ADDENDUM No. 2

REQUEST FOR QUOTATION No.:	1220-040-2024-033
TITLE:	HVAC UPGRADE, SPS
ADDENDUM ISSUE DATE:	JUNE 18, 2024
CLOSING DATE AND TIME:	PREFER TO RECEIVE SUBMISSION ON OR BEFORE JUNE 27, 2024

SURREY POLICE SERVICE (SPS) TRAINING CENTRE HVAC UPGRADE

2ND FLOOR COOLING

M-3

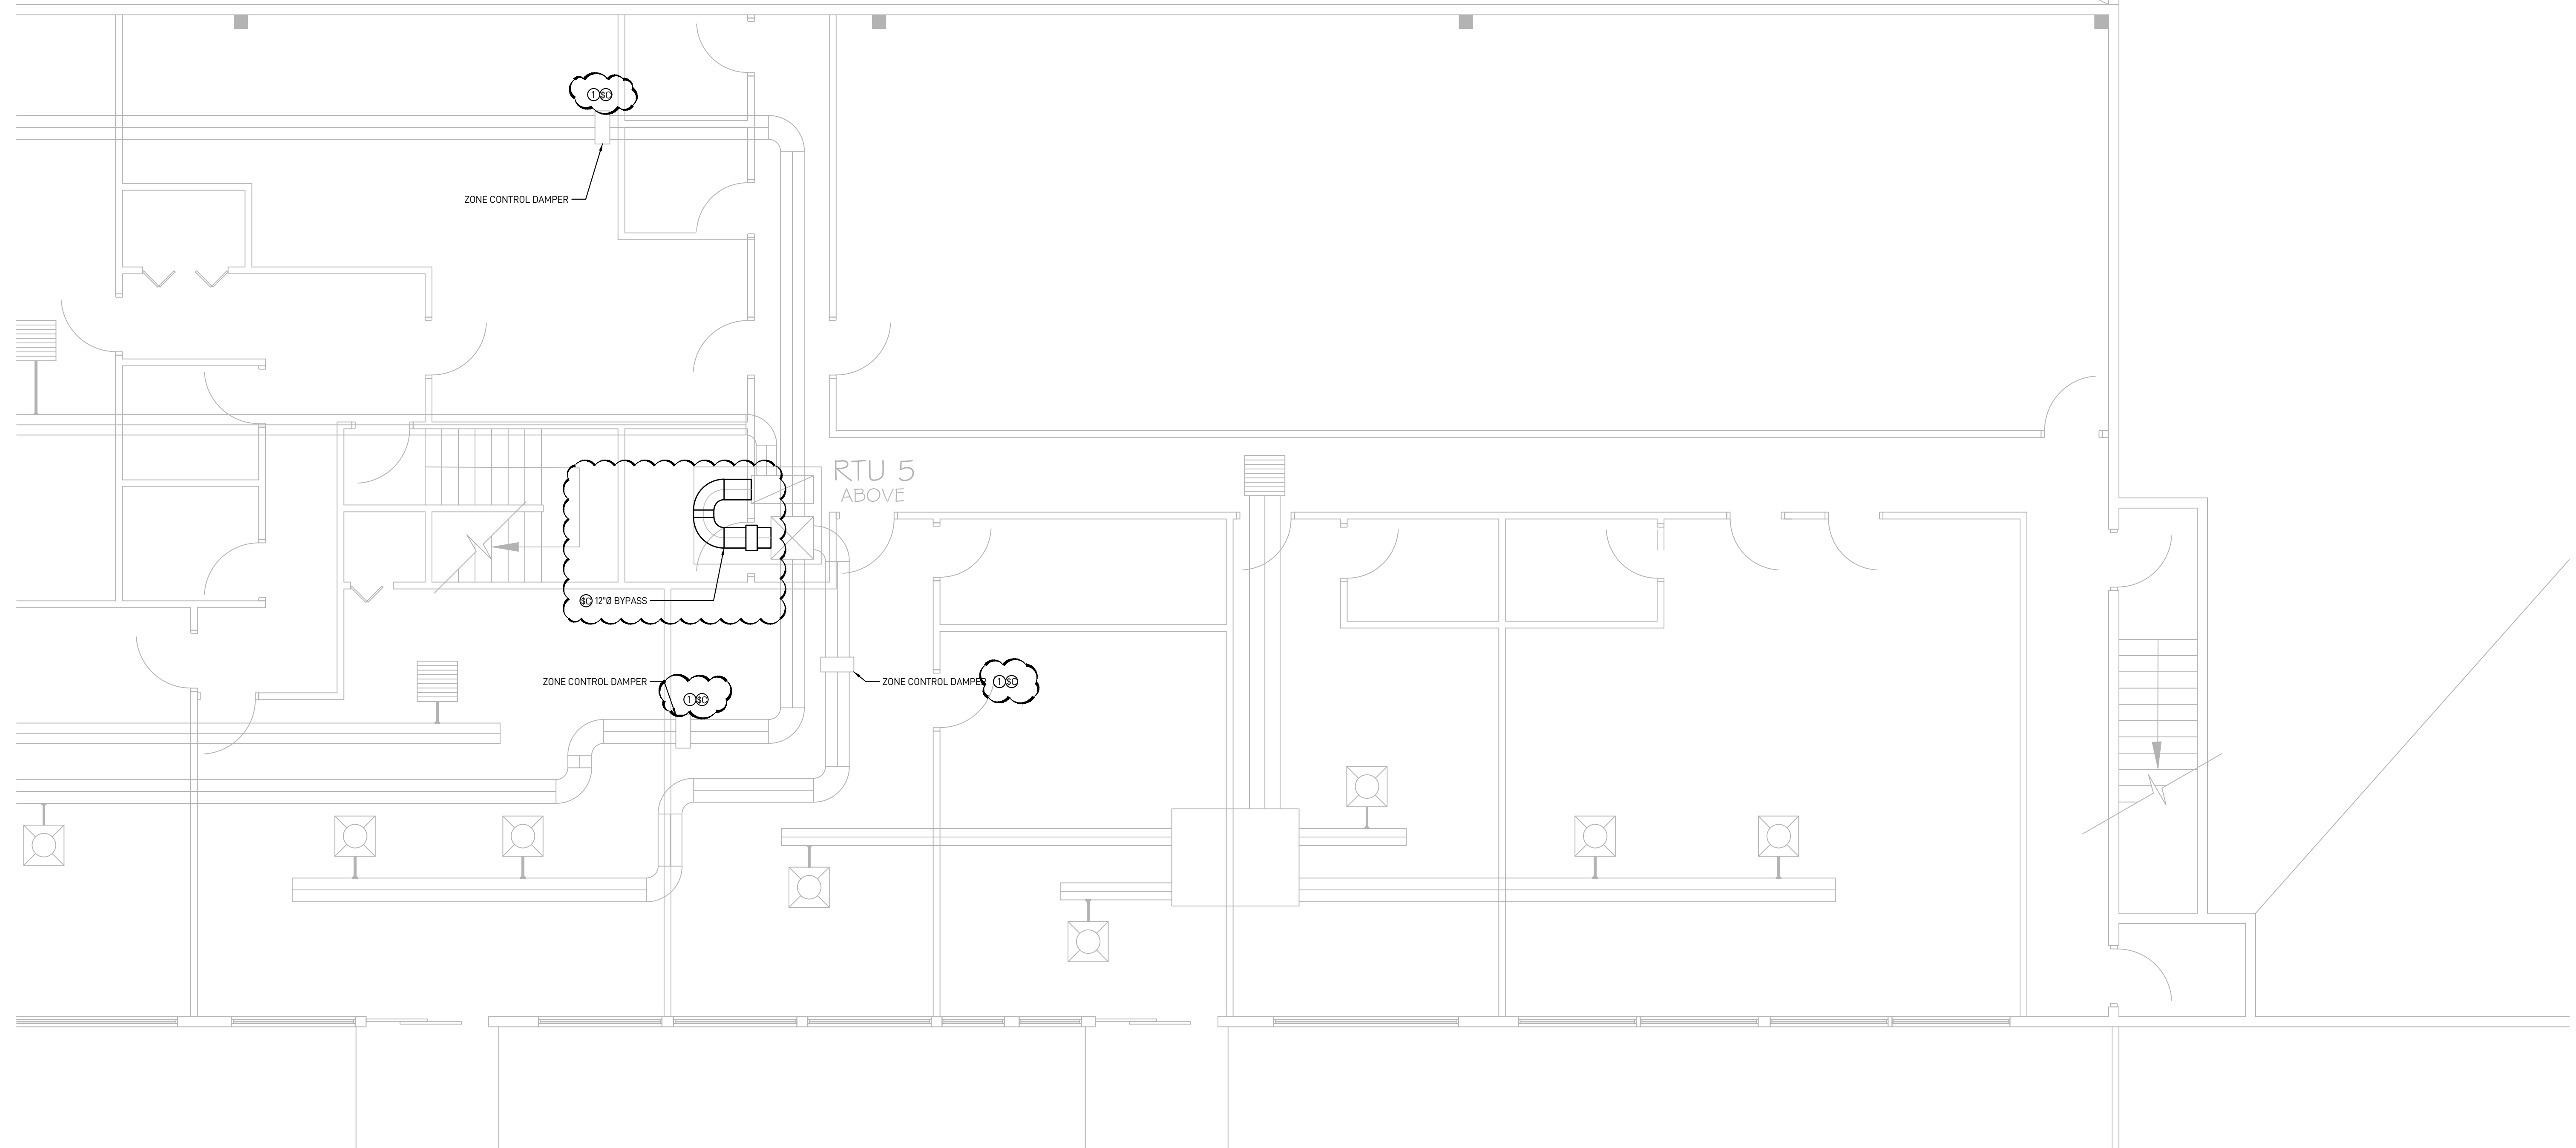
Q1. Could you please provide information on the replacement of TRU-5 zone control valve

- .1** Contractor to provide a separate price for the replacement of existing zone control dampers with new 8"Ø EH Price SDV. Units are to be 120V/1ph. Contractor to allow for the provision of a bypass complete with all associated ductwork. Bypass is to be provided a 12"Ø EH Price SDV. Allow for the provision of a Delta controller to allow for control of system. Delta controller is to be provided standalone controls with future DDC integrations.

③ CONTRACTOR TO PROVIDE A SEPARATE PRICE FOR THE REPLACEMENT OF EXISTING ZONE CONTROL DAMPERS WITH NEW 8"Ø EH PRICE SDV. UNITS ARE TO 120V/1PH. CONTRACTOR TO ALLOW FOR THE PROVISION OF A BYPASS COMPLETE WITH ALL ASSOCIATED DUCTWORK. BYPASS IS TO BE PROVIDED A 12"Ø EH PRICE SDV. ALLOW FOR THE PROVISION OF A DELTA CONTROLLER TO ALLOW FOR CONTROL OF SYSTEM. DELTA CONTROLLER IS TO BE PROVIDED STANDALONE CONTROLS WITH FUTURE DDC INTEGRATIONS.
